Service Bulletin

No. : MZ06-001

Model: SR9600

Subject: Vertical stripe lines appear on the screen with component output.

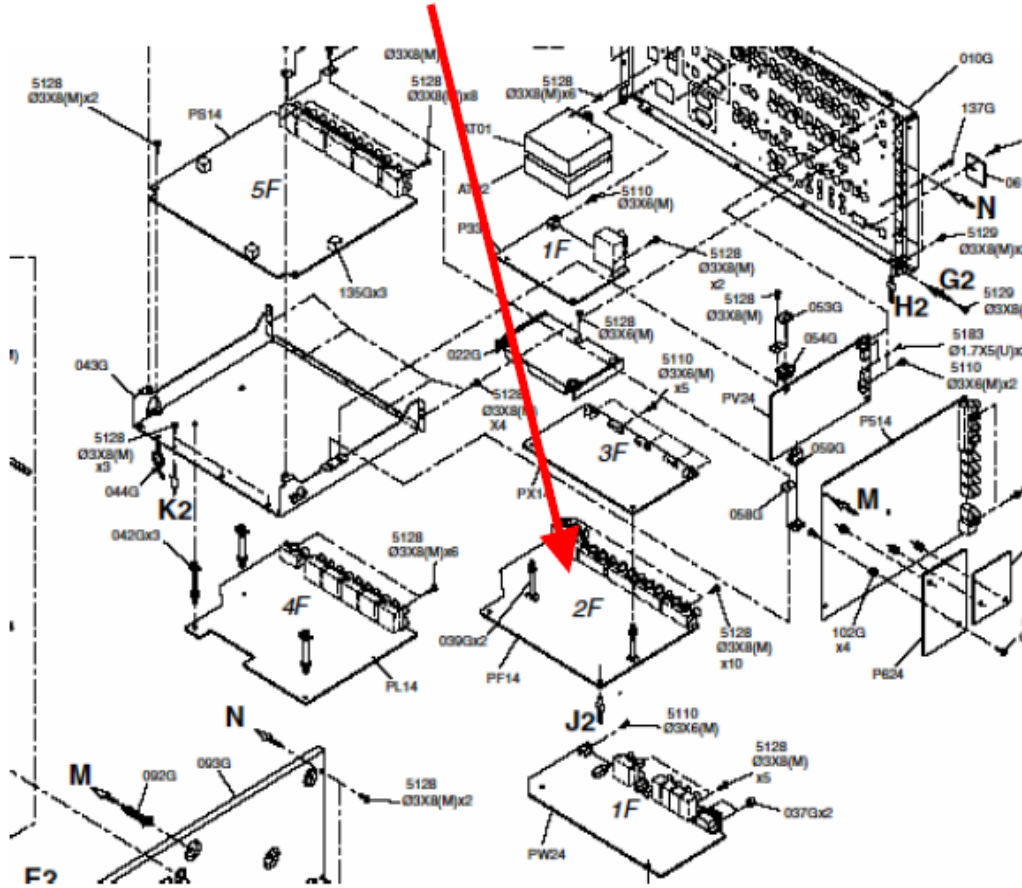
Symptom: 1. It only occurs when a 480i signal is input into VIDEO INPUT terminal or S-VIDEO terminal, and when a 480p signal is input into COMPONENT VIDEO terminal. (Both inputs into the same function)
2. Select this input function, a Vertical stripe line appears on a screen connected to OUTPUT1 and OUTPUT2 of COMPONENT VIDEO.
3. This problem will occur only when it connects with INPUT-1 (DVD) and INPUT-2 (DSS) component input. When connected with INPUT-3 and INPUT-4, the problem does not occur.

Solution: Add a SHIELD (copper foil) and solder the SHIELD to VIDEO DECODER PWB (PF14).
